## RESPONSE TO REQUEST FOR ADDITIONAL INFORMATION

### APR1400 Design Certification

Docket No. 52-046

RAI No.: 183-8197  
SRP Section: 03.07.02 – Seismic System Analysis  
Application Section: 3.7.2  
Date of RAI Issue: 08/31/2015

Figure 35 ATF – AB Slabs (1-F) at El. 55' – Node 9501 – Z Resp. due to Z Input – Uncracked

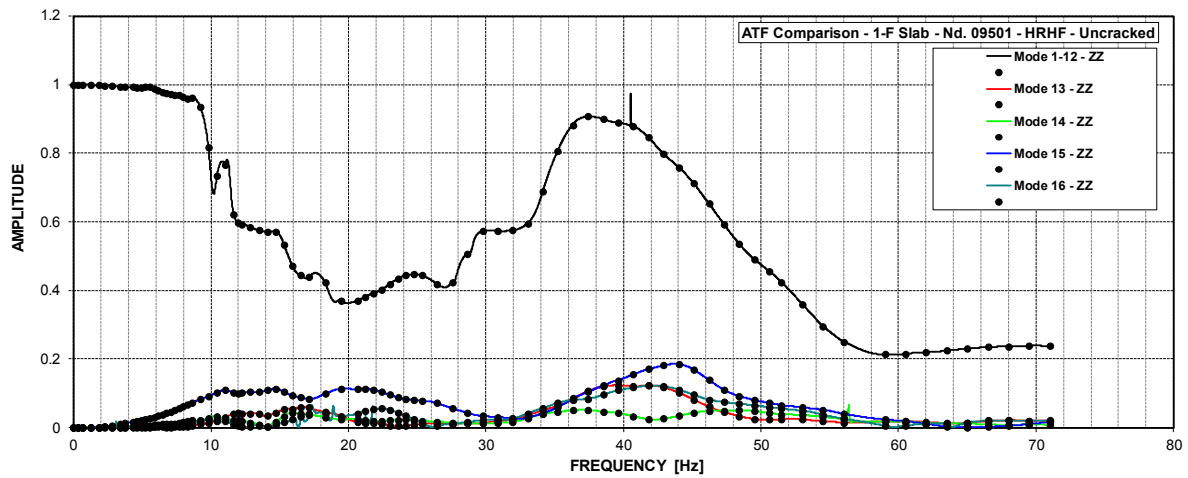
Per the convergence criterion as discussed in b-2 above, the vertical response ATF at representative nodes of the foundation basemat due to vertical input at the foundation level is computed to show the relatively low amplitude of higher modes 13 through 16, compared to the SRSS-combined modes 1 through 12. Figures 35 through 49 show the ATF for the nodes shown in Figure 34.

For each plot in these figures, the black data line named “Mode 1-12” is computed using a function of the MOTION module of ACS SASSI to combine the modal transfer function results using the rule of SRSS (ATF-SRSS). The results show that the vertical response amplitude of the higher modes 13 through 16 is small compared to the amplitude of the SRSS-combined modes 1 through 12.

Figure 49 ATF – AB Slabs (1-F) at El. 55' – Node 9501 – Z Resp. due to Z Input – Uncracked – Modes 13 through 16

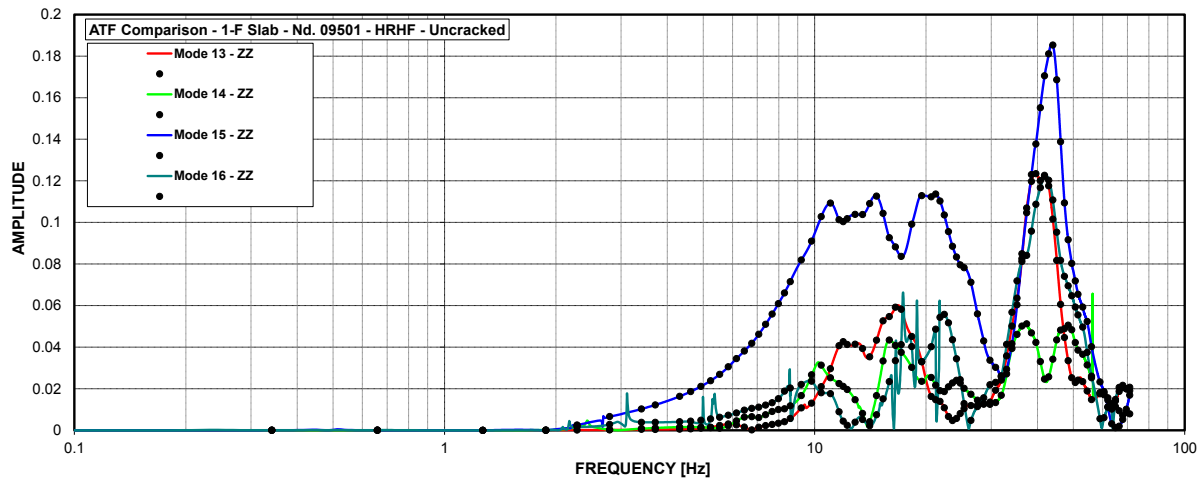
However, for the 1-F slab locations, the results generally do not show a decaying pattern from mode to mode, per Figure 49 (node 9501), as mode 15 has the highest amplitude of the 4 higher modes. This is also apparent in other locations throughout the NI model. Figures 50 and 51 show ATF results for nodes 12875 (2-F Wall, Uncracked) and 18165 (3-F Wall, Cracked), respectively. The results show that there is no clear decaying pattern from mode to mode up to mode 16 for these locations, as the ATF amplitudes of some modes from 2 through 16 are of the same magnitude or greater than mode 1.

Figure 82 ISRS – AB Shear Walls (1-M) at El. 68' – HRHF – Uncracked

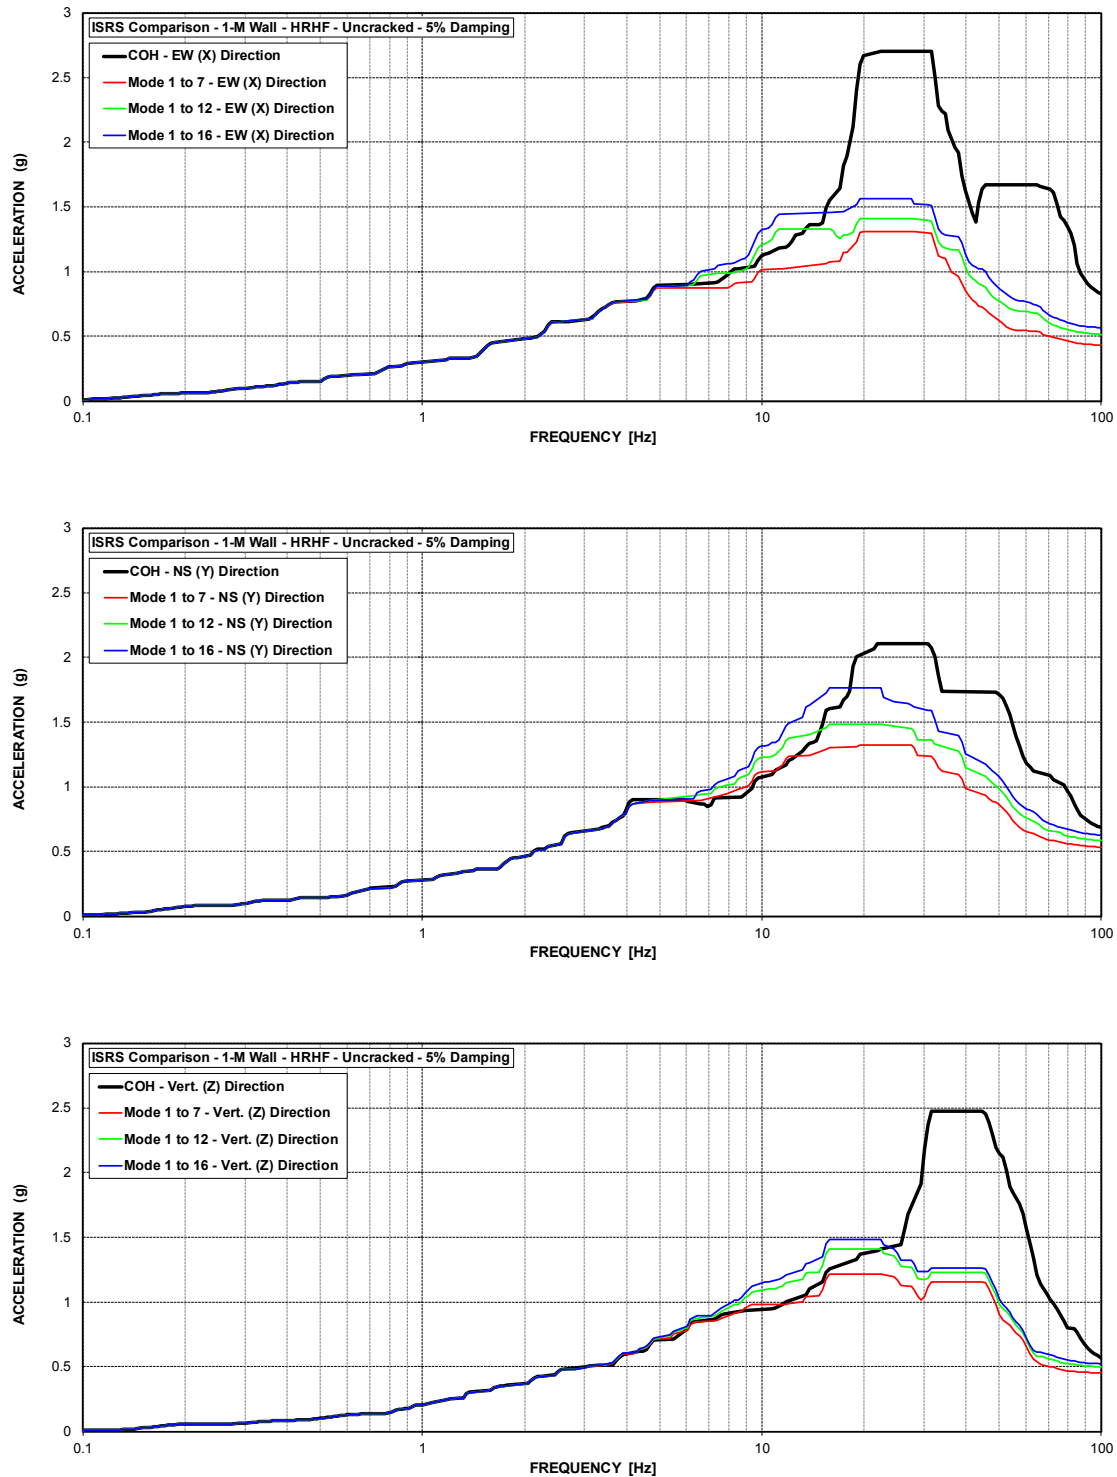
However, there are some locations below grade, such as the AB shear walls located below grade, as shown in Figures 82 through 84, where the criterion is not satisfied. In addition, two locations, AB shear wall 2-F for the uncracked case, and AB shear wall 3-F for the cracked case, do not satisfy the convergence criteria and have questionable responses, especially in the NS direction, as shown in Figures 85 and 86. The figures show a large difference between the combined 1-16 modes and the combined 1-12 modes, and between the combined 1-12 modes and the combined 1-7 modes. Figures 87 and 88 show the individual modes 13, 14, 15, and 16, for the 2-F uncracked NS response and the 3-F cracked NS response, respectively. The results show that mode 13 is the largest contributor for the 2-F uncracked case, and mode 14 is the largest

contributor for the 3-F cracked case. For these locations, the major contributions to the ISRS are due to the response contribution of a specific mode. The response combinations up to the specific modes have converged to the 16-mode-combined results.
